# Hayes Bridge Retail Park

## Transport Assessment Addendum

Document Reference: C21096/TA02

Proposed Building Layout Scale 1:300

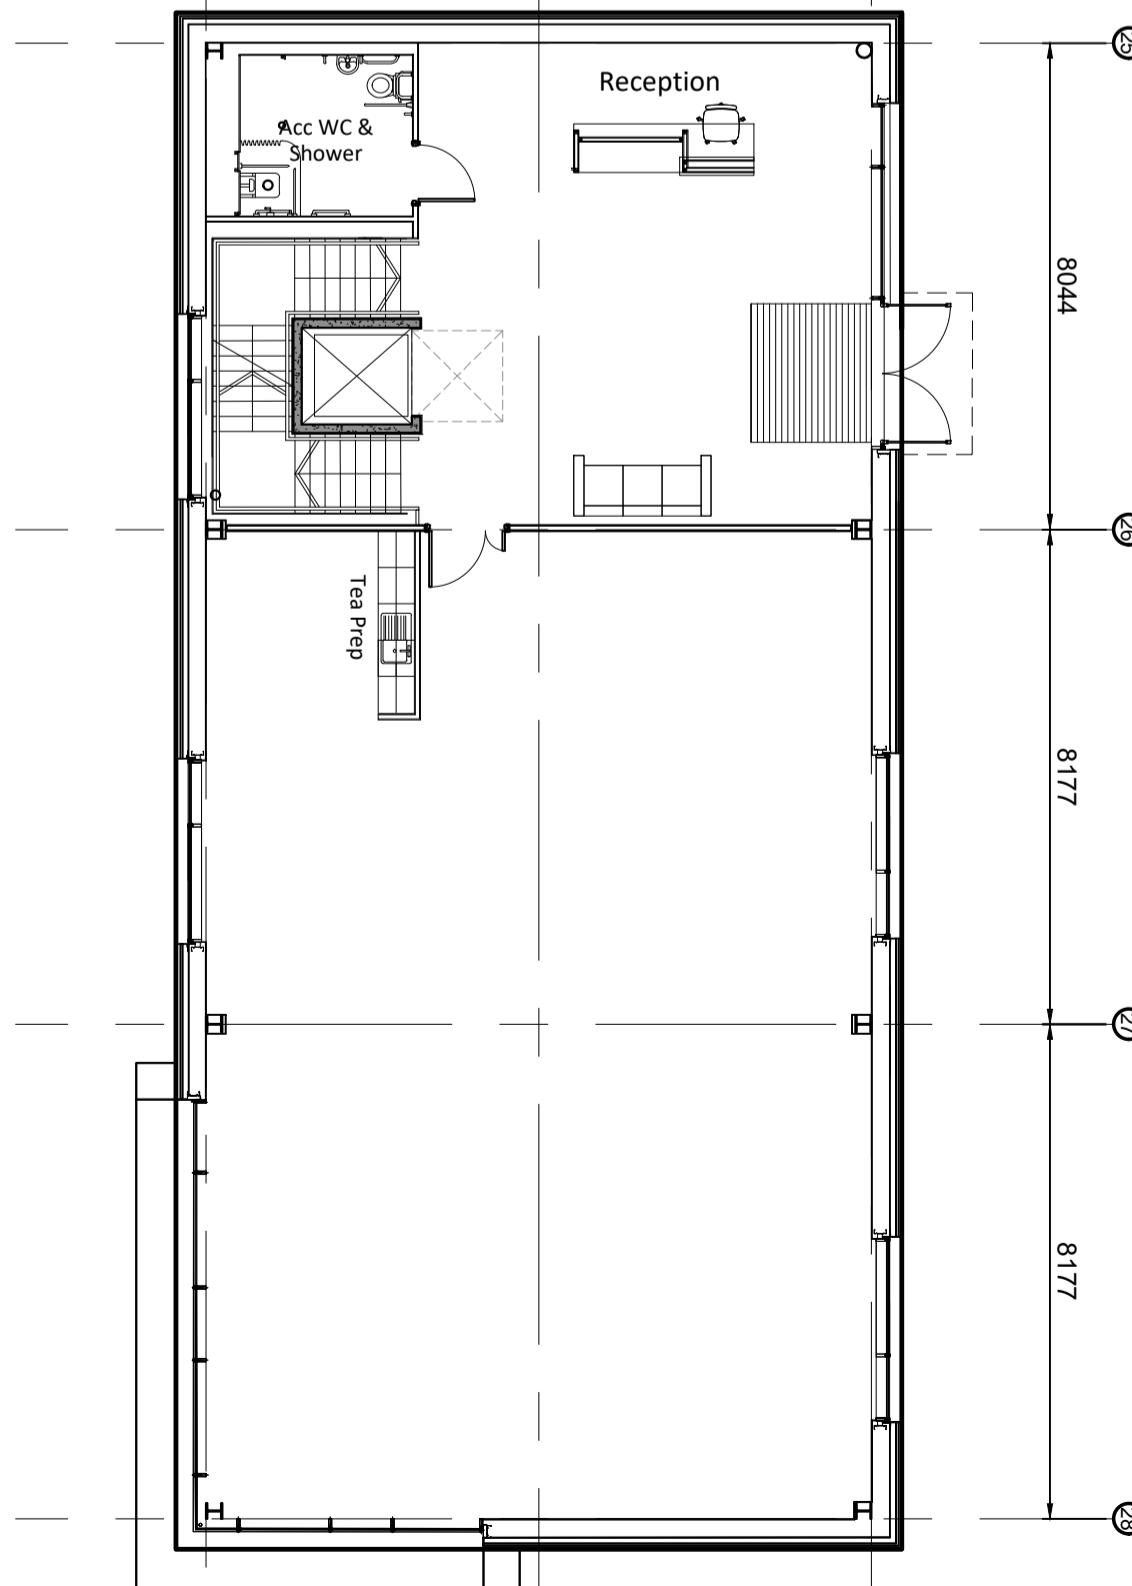
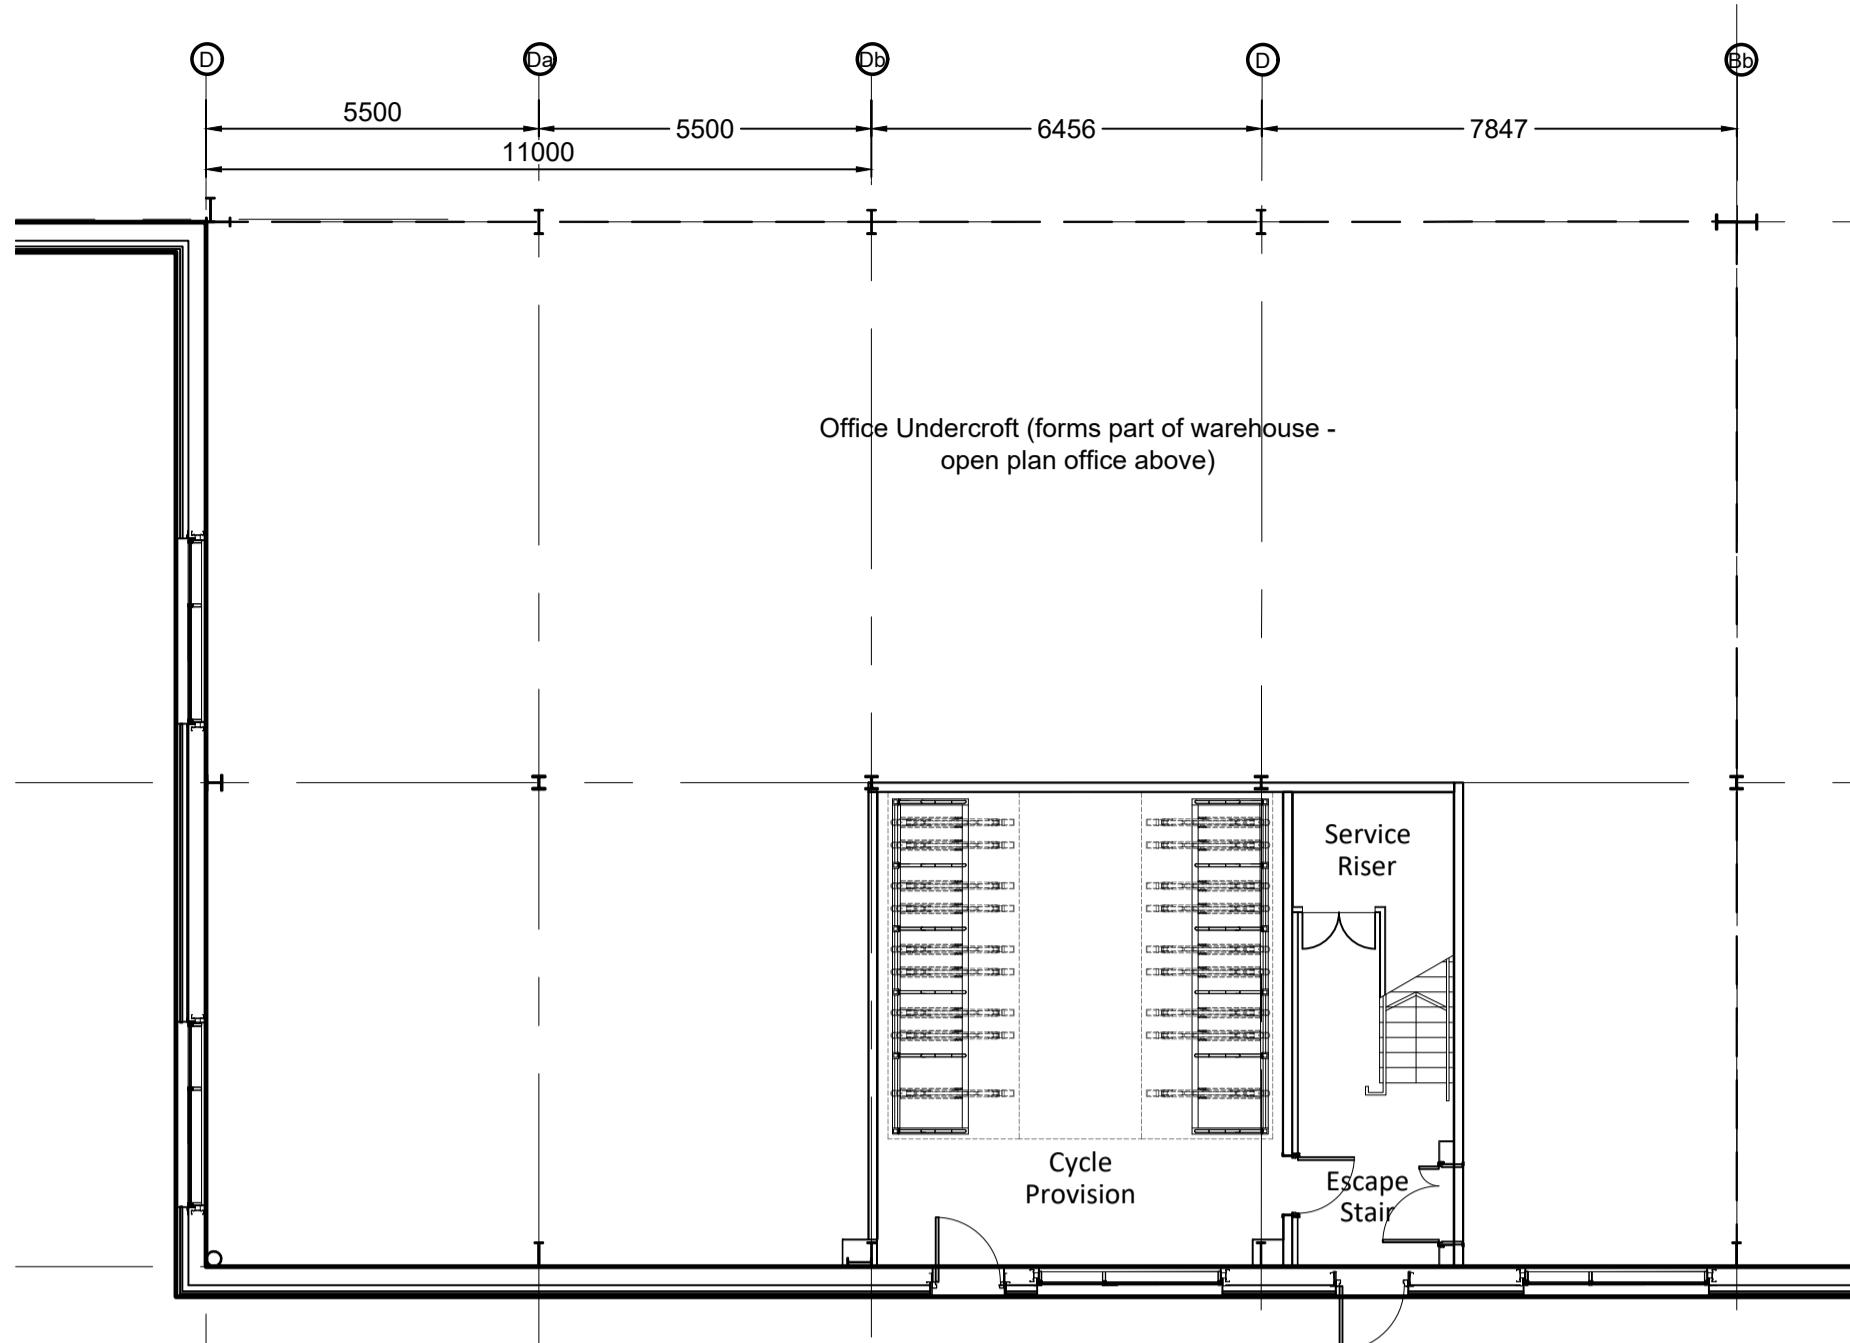
*It is noted that the applicant has revised the site layout, with an amended shared footway/cycleway connecting from the route adjacent to the site and linking to the building and the cycle parking area. The applicant has stated that this route is 3m – is this clear effective width?*

3.1.11 This is clear effective width connecting to the site, although the site proposals have since been amended further, including the shared footway / cycleway route which links to the building on a different alignment than the original submission which is shown on the layout plan in Appendix A.

## Appendix C General Arrangement of Proposed Amendments to Site Access

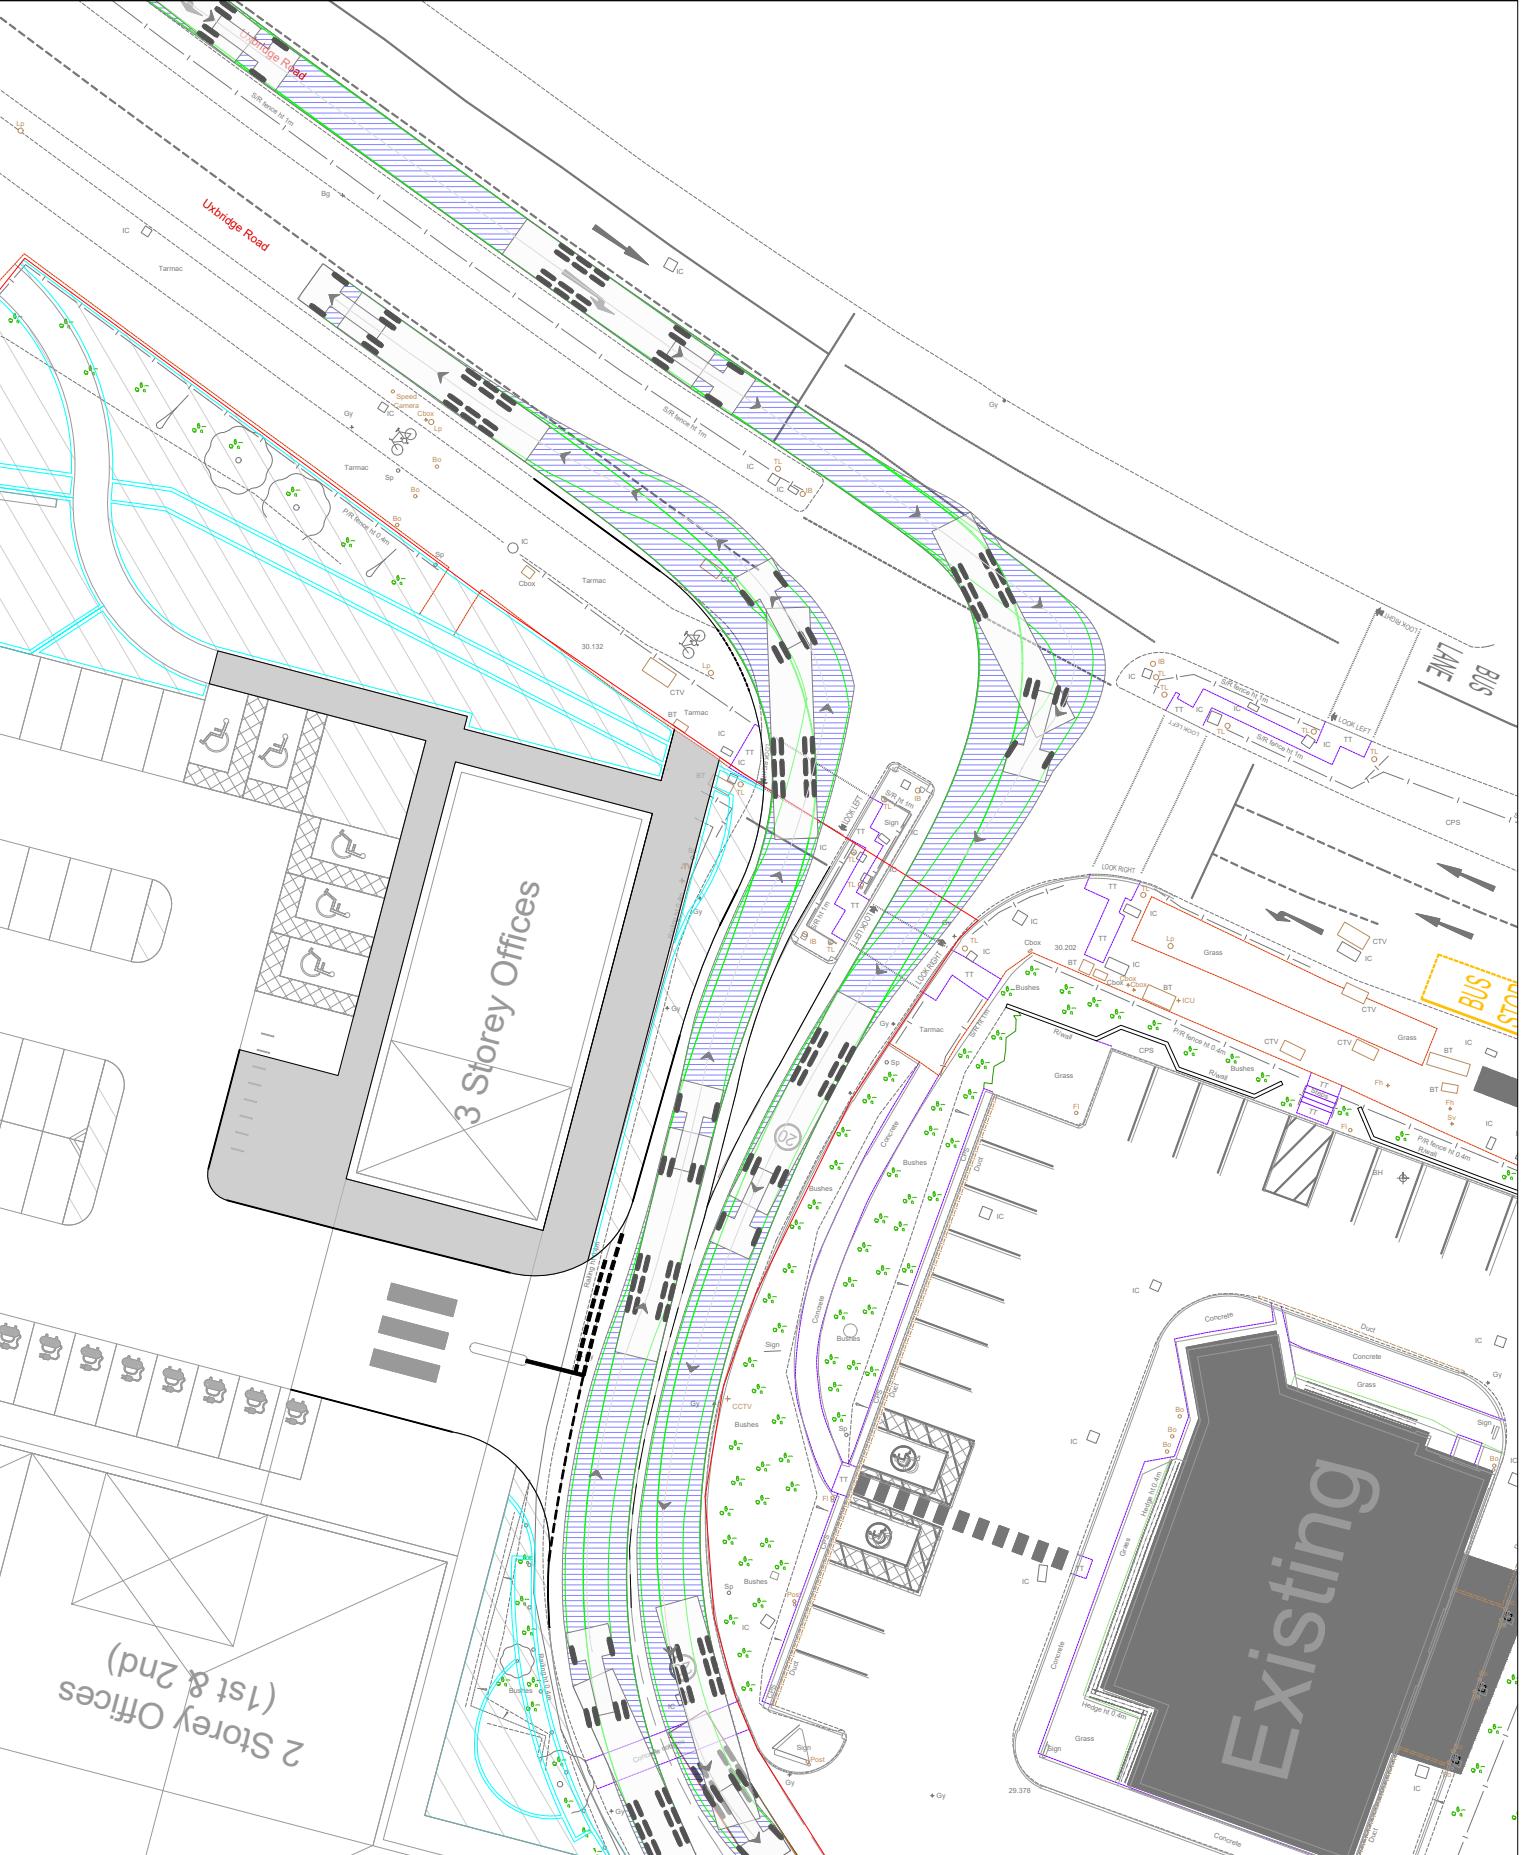
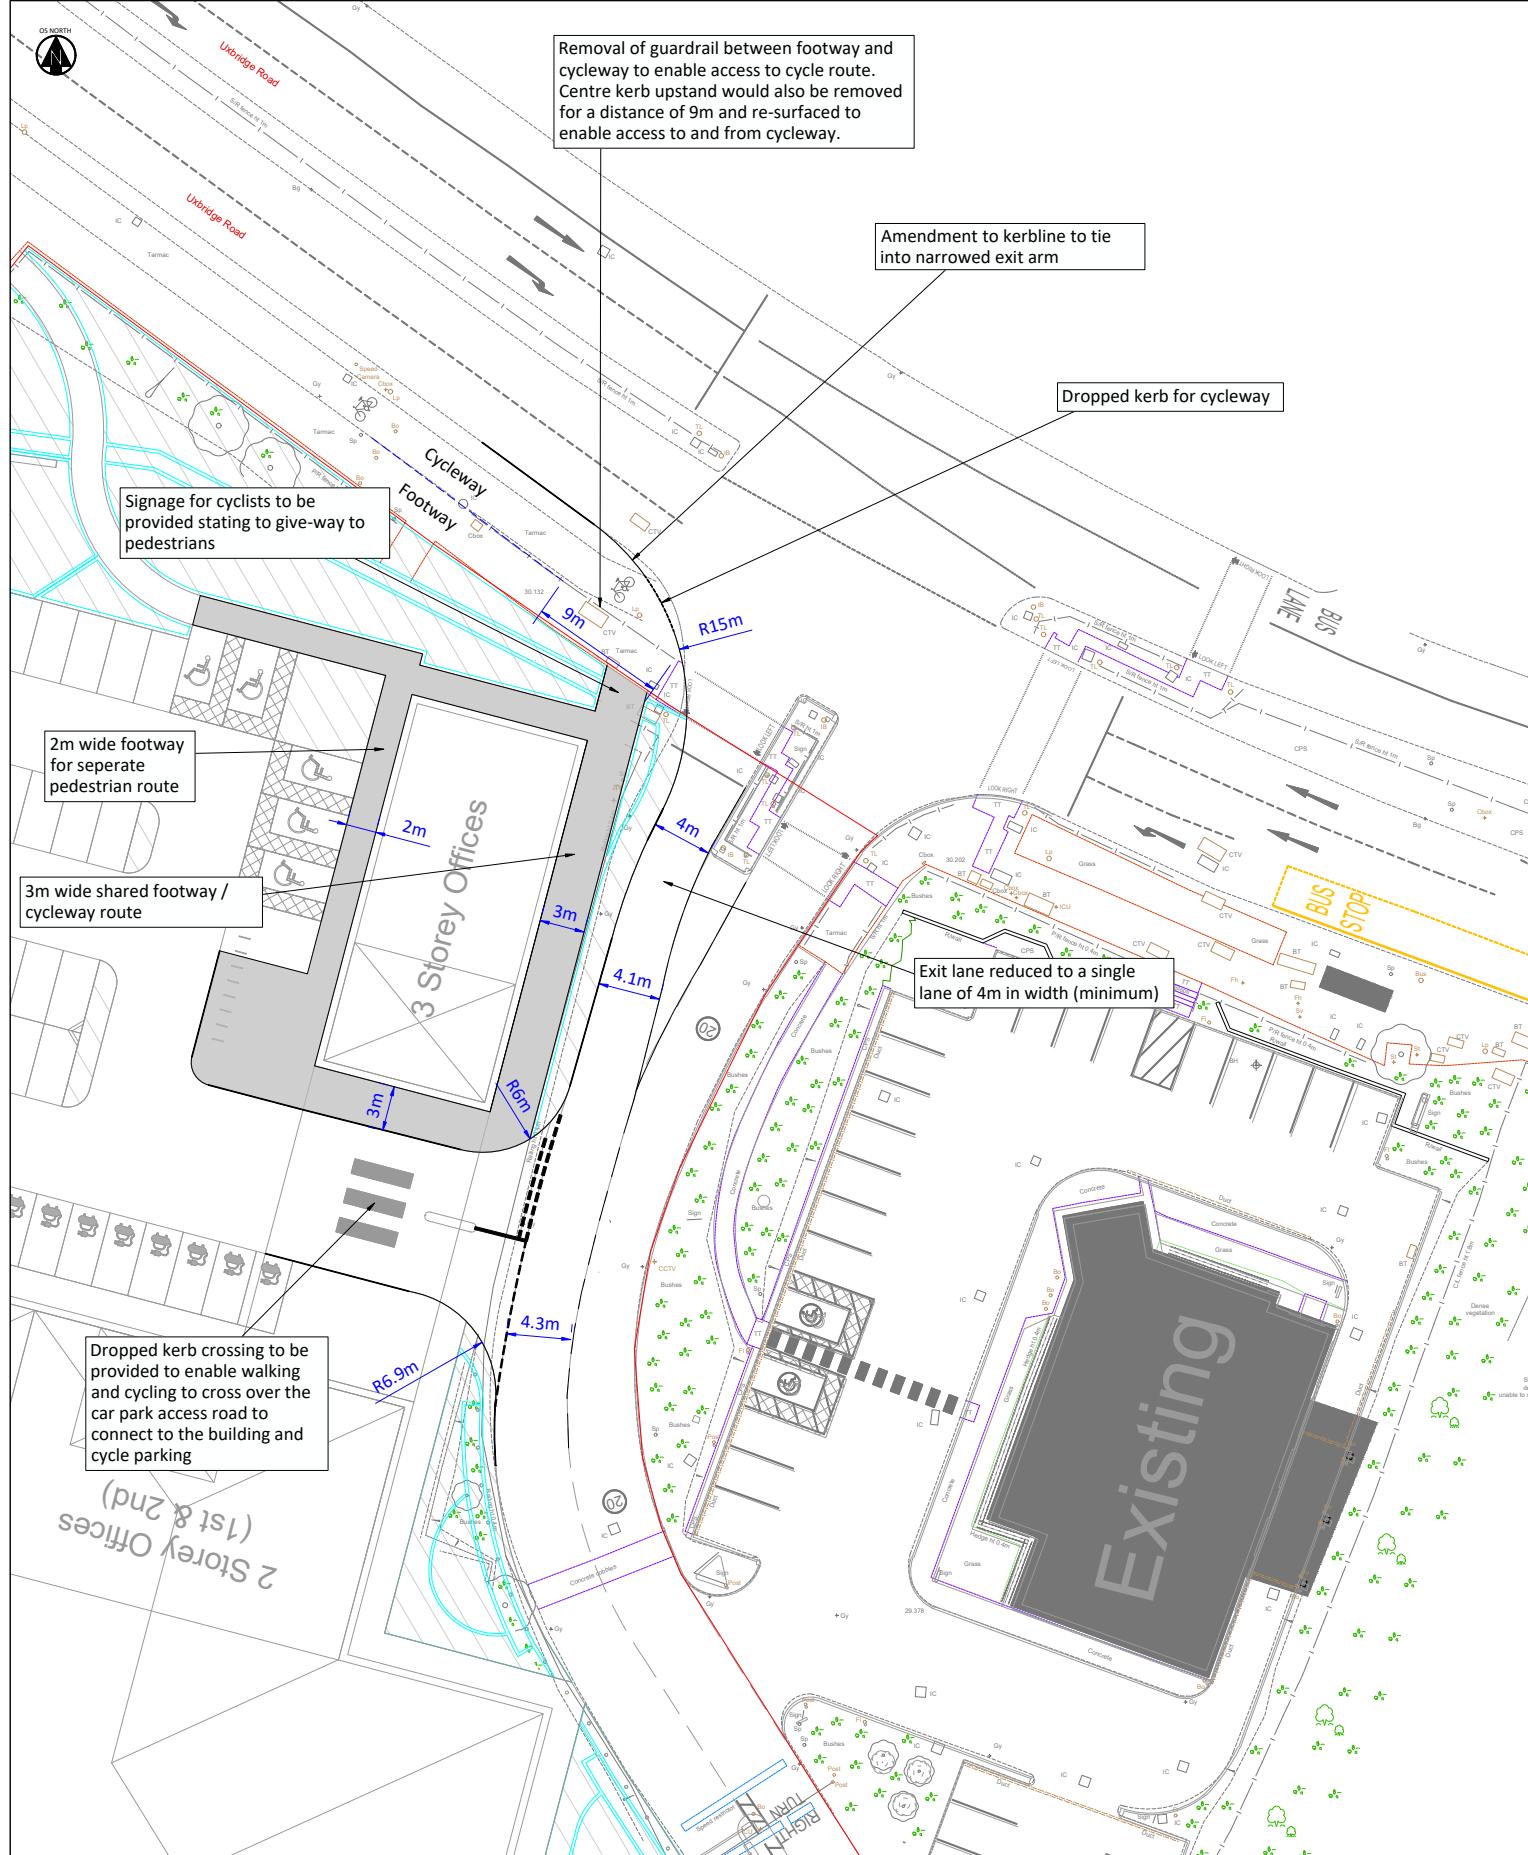
*The Highway Authority require that a further set of General Arrangement drawings are submitted that show how the needs of cyclists and pedestrians would be provided for at this junction to facilitate safe and convenient trip making by these modes. These plans should include proposed works to both the junction mouth and the shared use footway between the Grand Union Canal and the western boundary of the site. At the design stage the applicant is advised to the Transport for London, London Cycle Design Standards. These plans shall then be submitted to the Highway Authority for approval. The agreed works would then be delivered by the applicant under a 1980 Highways Act s.278 agreement.*

- 3.2.6 The S278 agreement would therefore relate to the delivery of the minor amendment to the kerbline at the access, reduction in width of the exit lane to a single lane, minor road marking amendments and removal of the guardrail and central kerbing for 9m within the vicinity of the new footway connections point as shown in the general arrangement drawing in Appendix C. This may require minor amendments to dropped kerbs, tactile paving and drainage which would all be agreed as part of the technical approval process. The further improvements to the active travel route on each side of the access would then be delivered by LBH through the contribution provided by the applicant.
